Accessibility Survey

City of Downey Gneiss Avenue - Alameda Street To Cul-de-sac

Date of Inspection
1/30/2017

Prepared By
Disability Access Consultants
(800) 743-7067

Sidewalks : 60X60 Turn Area

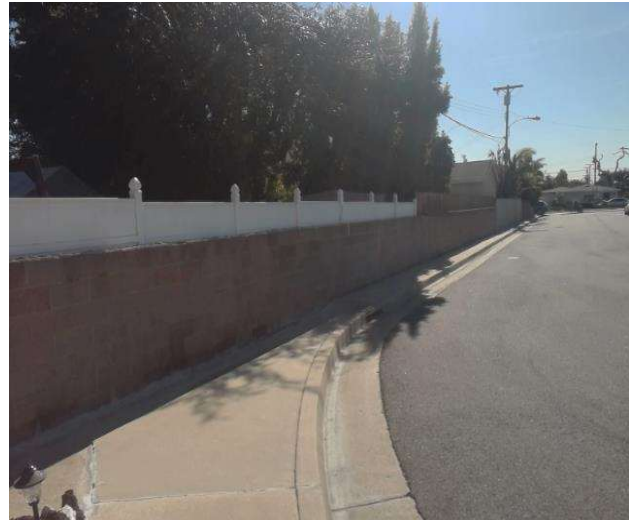
There is no 60X60 turn area at every 200 feet.

On-Site Finding Not Found

Provide a 60X60 turn every 200 feet on the sidewalk.

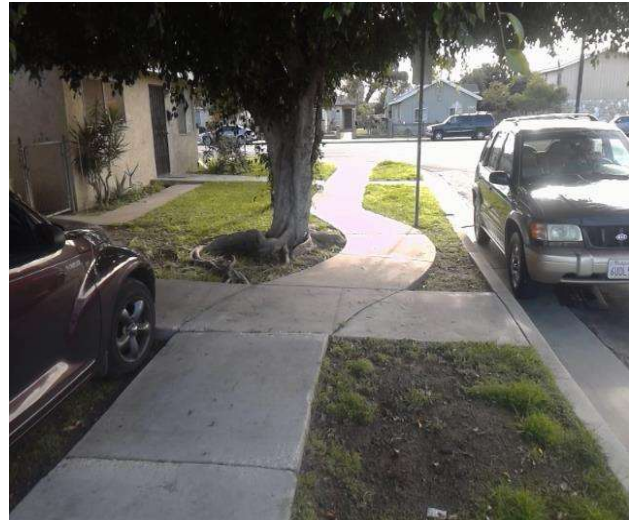
Sidewalk cross slope is not compliant.

On-Site Finding 3.50 percent for 45.00 feet

Repave the sidewalk surface with the recommended cross slope.

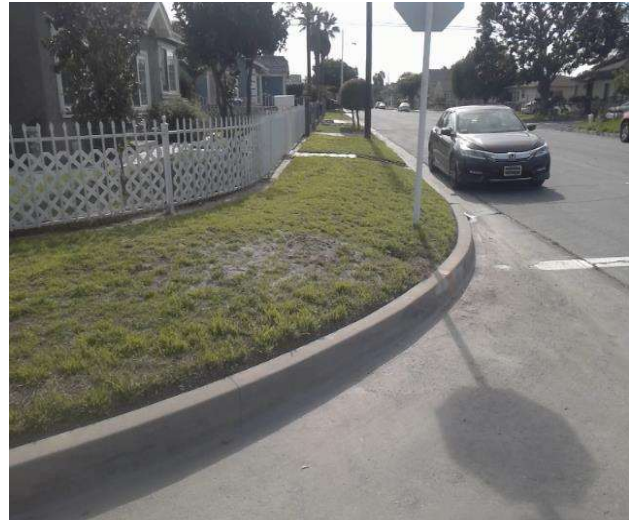
There is a curb on the designated path of travel.

On-Site Finding Not Compliant

Provide a compliant curb ramp.

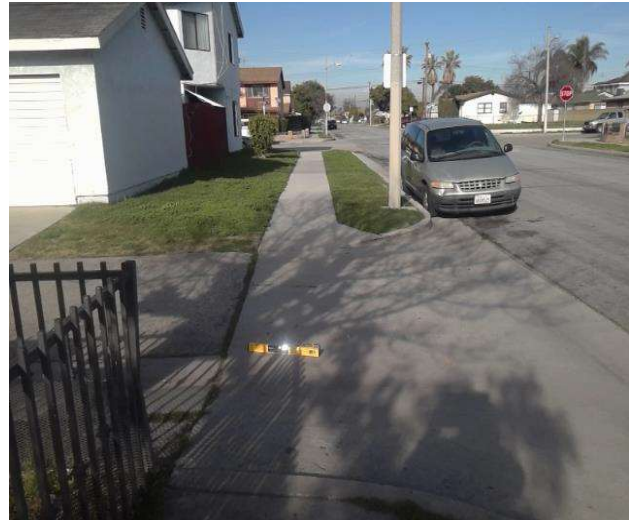
Slope at vehicular traffic is not compliant.

On-Site Finding 9.30 percent

Repave the surface to provide a compliant slope.

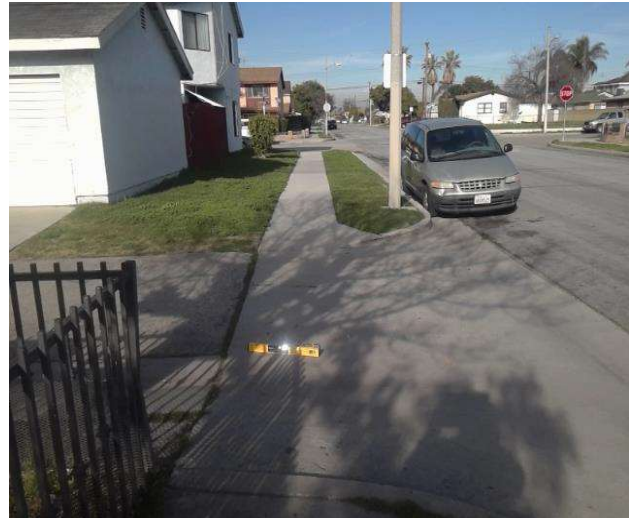
Cross slope at vehicular traffic is not compliant.

On-Site Finding 4.00 percent

Repave the surface to provide a compliant cross slope.

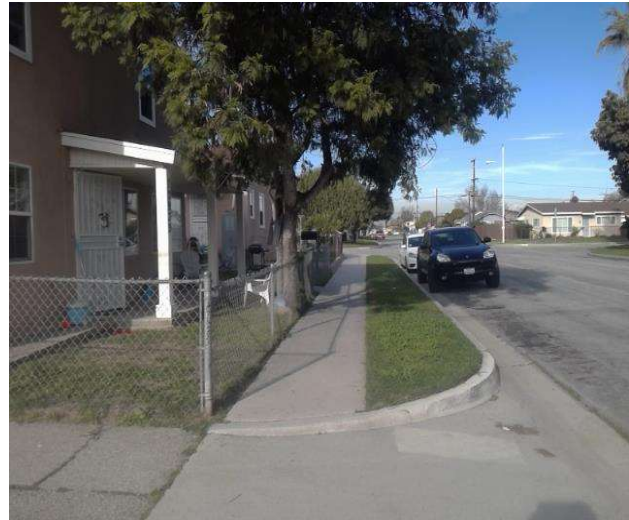
There is a curb on the designated path of travel.

On-Site Finding Not Compliant

Provide a compliant curb ramp.

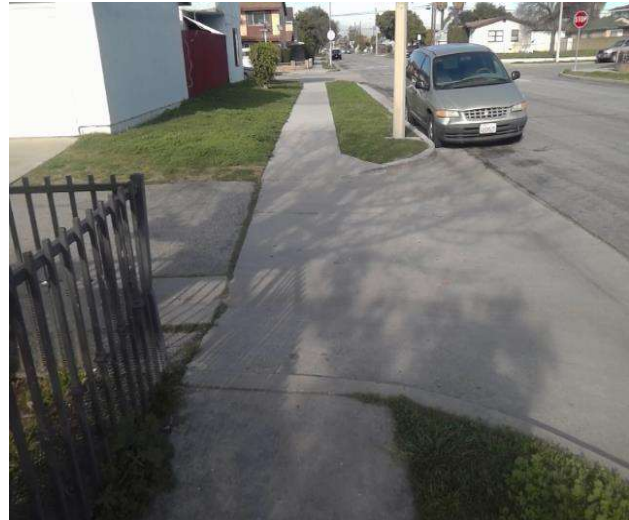
There is a curb on the designated path of travel.

On-Site Finding Not Compliant

Provide a compliant curb ramp.

Sidewalks , Change in Level : Change in Level Non Beveled

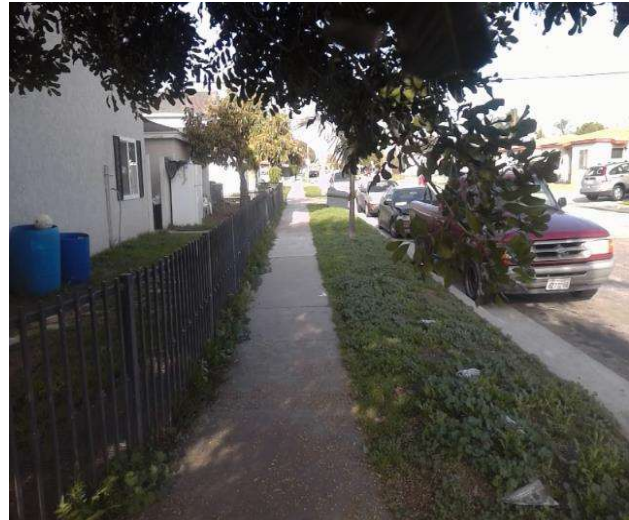
There is a change in elevation greater than recommended value.

On-Site Finding 52.00 inches

Ensure that the change in elevation is within the recommended value.
